HISTORIC AND DESIGN REVIEW COMMISSION

June 07, 2017

HDRC CASE NO: 2017-243
ADDRESS: 3100 BROADWAY
LEGAL DESCRIPTION: NCB 3864 BLOCK 10 LOT 7
ZONING: C-2 RIO-1
CITY COUNCIL DIST.: 2
APPLICANT: Naeem Husain/Ezzi Signs
OWNER: Evan Ketabchi/Duwest Realty
TYPE OF WORK: New Signage
REQUEST:

DRIVE-THRU ELEMENTS

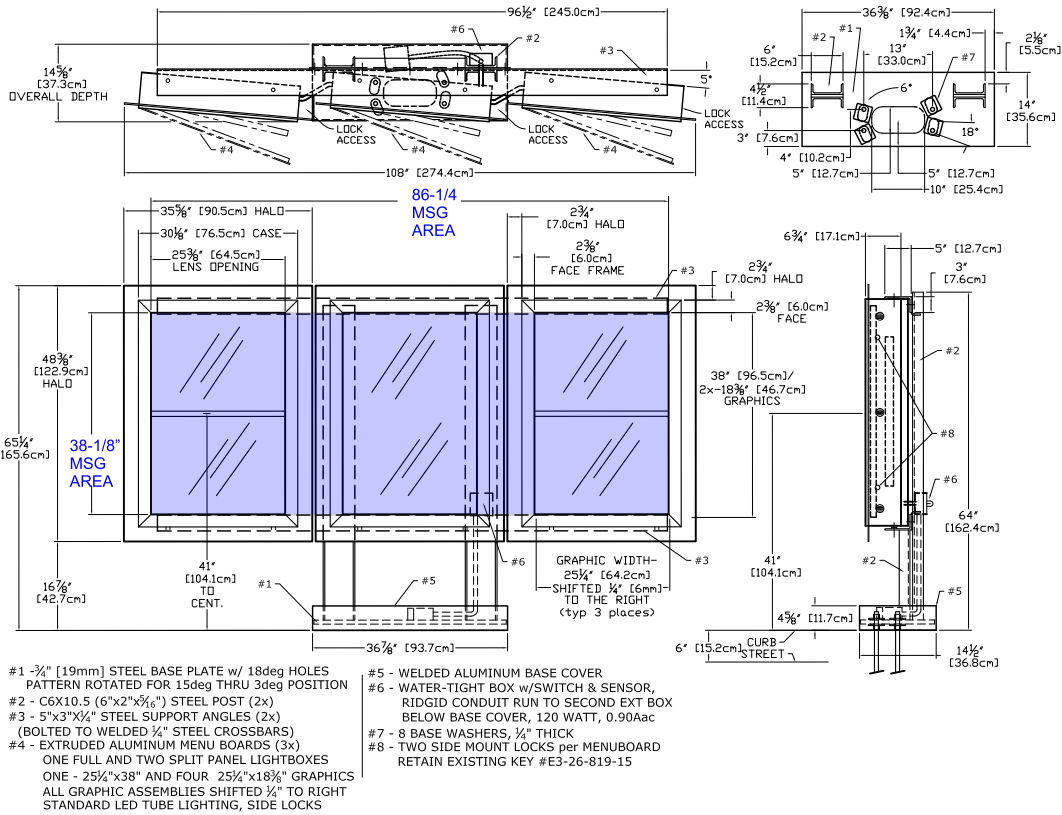
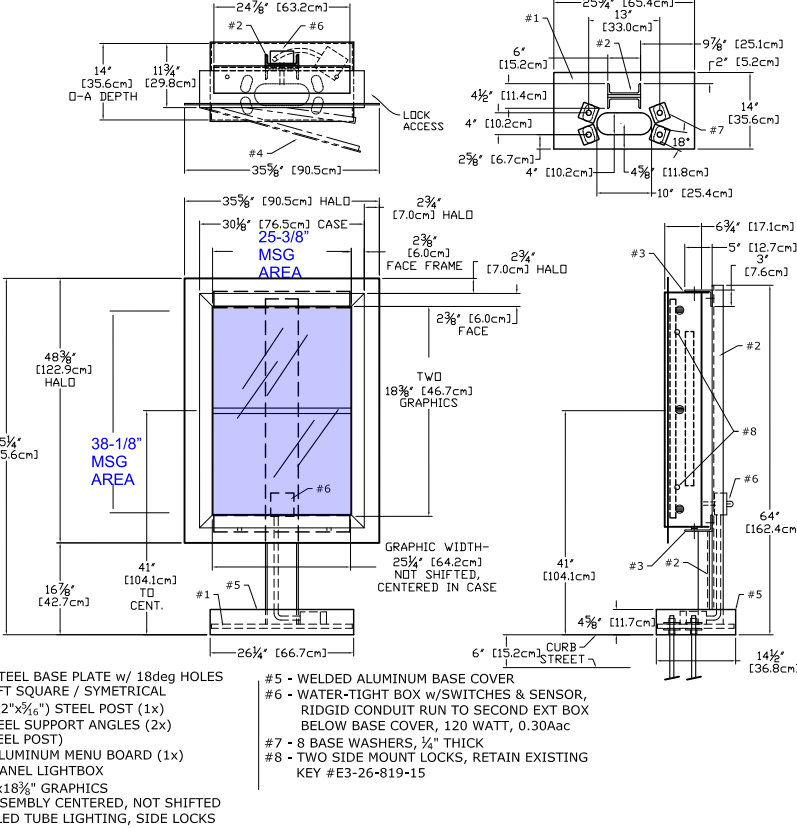
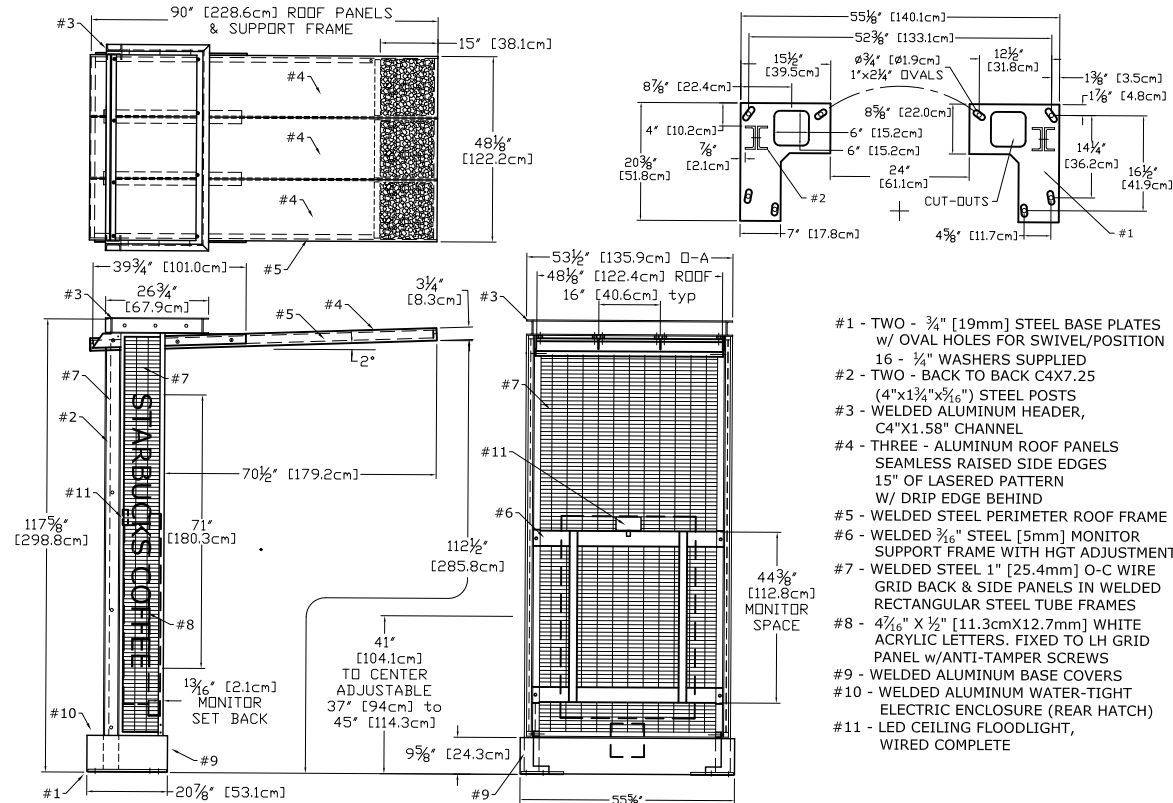
- h. DRIVE THROUGH MENU – The applicant has proposed to install a drive through menu cabinet. This sign is identified as signs H through L. Staff finds this installation to be appropriate given its location and purpose.
